Federal Motor Vehicle Safety Standards; Platform Lifts for Motor Vehicles; Platform Lift Installations in Motor Vehicles

ACTION: Notice of proposed rulemaking (NPRM); grant in part, denial in part of petitions for rulemaking.

SUMMARY: This document responds to six petitions for rulemaking to amend the Federal motor vehicle safety standards on platform lift systems for motor vehicles. The purpose of these standards is to prevent injuries and fatalities during lift operation. Pursuant to the agency's partial grant of the petitions, NHTSA proposes to amend the platform lift standards to revise the lighting requirements for lift controls; the location, performance requirements, and test specifications for threshold warning signals; the specifications for the wheelchair test device; the wheelchair retention device and inner roll stop tests; and the lighting requirements for public use lifts.

FIGURE 2

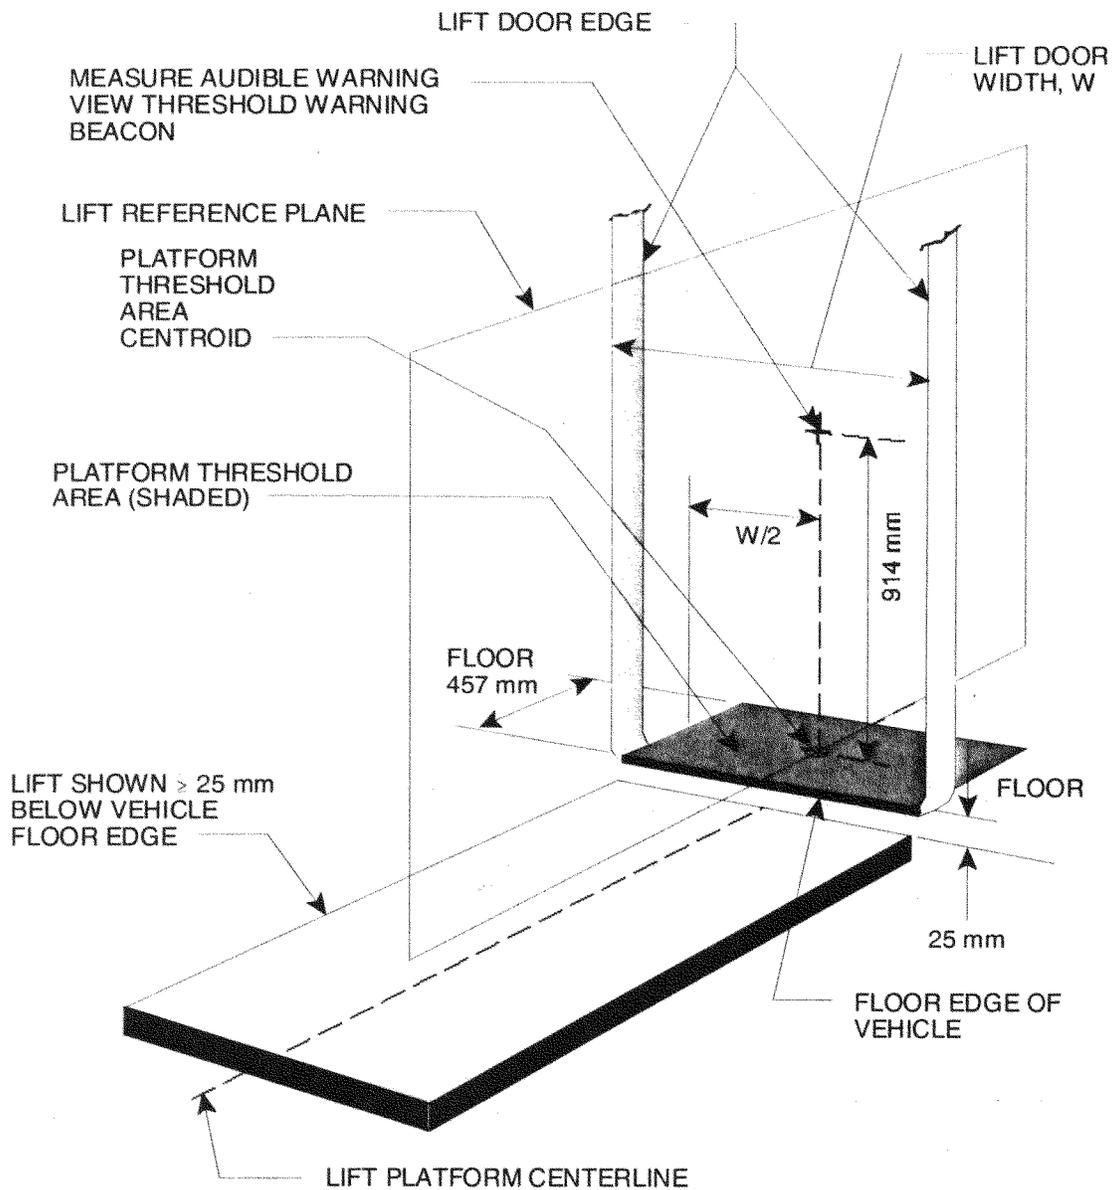
B. Correct Figure 2 in FMVSS No. 403 To Make it Consistent With the Threshold Beacon Warning Requirements in S6.1.6

It has come to NHTSA’s attention that a dimension in Figure 2 is incorrect. The height of the measurement point from which the intensity of the threshold audible warning is measured and the threshold warning beacon must be visible is identified as 919 mm. Because S6.1.6 provides that this measurement point is 914 mm (3 feet), we are proposing to replace Figure 2 with revised Figure 2, which shows a measurement point of 914 mm (3 feet), consistent with the requirements of S6.1.6.

S6.1.6 The intensity of the audible warning and visibility of the visual warning required by S6.1.2 and S6.1.3 is measured/observed at a location 914 mm (3 ft) above the center of the platform threshold area. (See Figure 2).
